## TENTATIVE PARTITION STAFF REPORT

Cox (20-060)

Approval of a tentative Land Partition of one existing lot into two parcels in the General Commercial Zone ("C-2").

Figure 1 Tentative Partition Plat

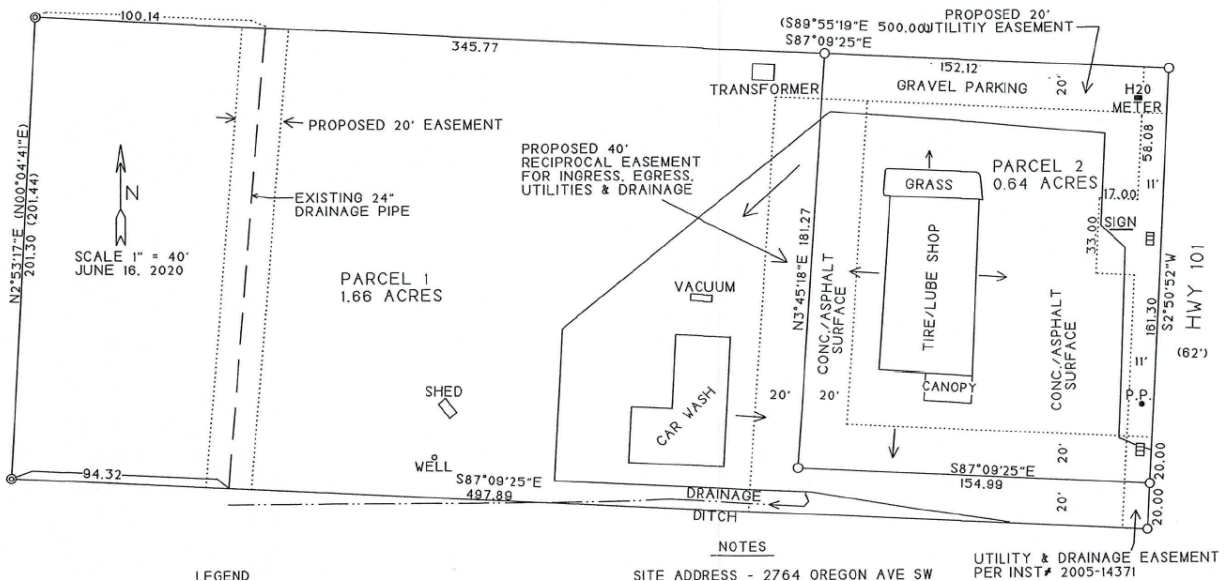
*After partition, all resulting lots must directly access an open street with a minimum frontage dimension of forty (40) feet. Parcel 1 has 20 feet of street frontage and Parcel 2 has 181.30 feet of street frontage. Staff finds this criterion has not been met.*

Staff finds that these criteria have not been met. The lot can be split without requiring a flag lot, and the subject property abuts an arterial.

The applicant submitted an application for a Land Partition, separating the two existing structures on the lot onto separate parcels. The applicant submitted a site plan, as well as a deed and information about the existing easements. No narrative or findings were submitted for this application, so Staff has interpreted the content of the site plan for the tentative partition to prepare this Staff Report. The applicant has proposed to create a flag lot, which will use a proposed 40' reciprocal access easement for ingress, egress, utilities, and drainage (20' on each property) for access from Highway 101. The City's flag lot standards preclude this property from dividing in the manner presented.

The applicant has also shown a proposed drainage system that will output on both the properties to the north and south. No information has been provided about the proposed drainage easement that will incorporate an existing 24" drainage pipe. At a minimum, a drainage plan should be required to better understand how each of these properties will be responsible for managing their drainage after the partition.

Finally, the applicant has not clearly shown how they will separate the utilities for the two structures, nor have they shown a separator that both the carwash and tire/lube shop are tied into. Staff recommends that an additional sewer and water meter be installed to serve either the carwash or the tire/lube shop, and that a plan be presented to explain how the separator will either be shared by the two structures or decommissioned.

This application has not met the minimum requirements of the city's land partition code. When initially deemed incomplete, staff indicated that the applicant shall establish separate water and sewer service for each lot and indicate where those utilities will be located. A new site plan was submitted that showed a 20-foot utility easement on the north side of the property, but did not indicate how and where new utility service will be located. Further, staff is still concerned about the known existing separator that has not been shown on plans and which is connected to both existing structures.

Initially, the applicant proposed that parcel 1 would retain 40 feet of physically accessible street frontage. In their resubmittal after being deemed incomplete, the applicant changed that access to only 20 feet, which does not meet the requirements of the city code. It is possible that the applicant may reapply with a different configuration, however at that point, staff would recommend including a circulation plan to show how each structure will continue to operate without use of the other.

Finally, the applicant has not clearly shown how drainage on the two properties will be dealt with. Oregon drainage law allows adjoining landowners to have a normal course of natural drainage maintained, meaning that the lower owner must accept water that naturally comes to their land from above, but is entitled to not have that normal drainage changed or substantially increased. The applicant

has proposed an easement along the existing drainage pipe in the rear of parcel 1 that drains onto a surrounding property, which we assume would be in favor of Parcel 2. There is also an existing storm drain in the 11' easement on the east side of the property. The plan shows that drainage currently runs off the property in a drainage ditch that veers onto the property to the south before entering the pipe. If the Planning Commission chooses to approve this application, staff recommends that a condition be placed on the application to contain all drainage on the subject property and supply information about where each parcel will drain to (the drainage pipe or the storm drain system).

Staff finds that the application has not met the minimum requirements of the code, and therefore recommends denial. The application proposes a flag lot for access, which is not permitted by code.
